# Access Compliance Report

## Public Rights-of-Way

Intersection ID: 15785	Main Street: CHEROKEE_PL	Cross Street: COLVILLE_RD	Location: NE
ADA ID: ABBE04310582	Ramp Type: Perp	Initial Pass/Fail: Fail	Overall Compliance: No
Severity Score: 21.25			
Codes/Mitigation Info/Possible Solution		Field Measurements/Component Compliance

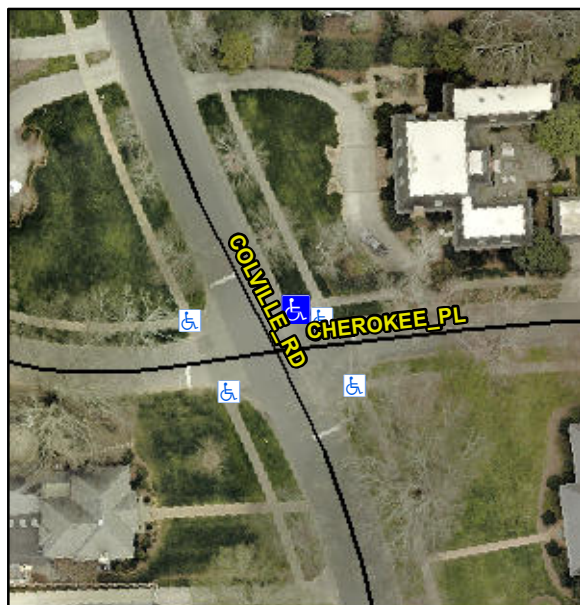
**Remove & Replace Entire Ramp.**

**R304.5.1, R304.5.3**

Compliance	Description	Data	Compliance	Description	Data
N/A	Ramp Length (in)	48.0	Yes	Ramp Slope (%)	7.5
No	Ramp Width (in)	44.0	No	Ramp XSlope (%)	6.0
N/A	Flare Type LT	N/A	N/A	Flare Type RT	N/A
N/A	Flare Slope LT (%)	N/A	N/A	Flare Slope RT (%)	N/A
N/A	Flare Traversable LT?	N/A	N/A	Flare Traversable RT?	N/A
N/A	Landing Length (in)	N/A	N/A	DWS Provided?	N/A
N/A	Landing Width (in)	N/A	N/A	DWS Contrast?	N/A
N/A	Landing Slope (%)	N/A	N/A	DWS Length (in)	N/A
N/A	Landing X Slope (%)	N/A	N/A	DWS Full Width?	N/A
N/A	Landing Curb? (Y/N)	N/A	N/A	DWS Offset (in)	N/A
N/A	Shared Landing?	N/A			
N/A	Gutter Ponding?	N/A	N/A	Gutter Slope (%)	N/A
N/A	Gutter Lip Ht (in)	N/A	N/A	Gutter X Slope (%)	N/A
N/A	Painted X Walk1?	No	N/A	Painted X Walk2?	N/A
	X Walk 1 Direction	To W		X Walk 2 Direction	N/A
N/A	X Walk 1 Width (in)	N/A	N/A	X Walk 2 Width (in)	N/A
	X Walk 1 Slope (%)	2.2		X Walk 2 Slope (%)	N/A
	X Walk 1 X Slope (%)	3.5		X Walk 2 X Slope (%)	N/A
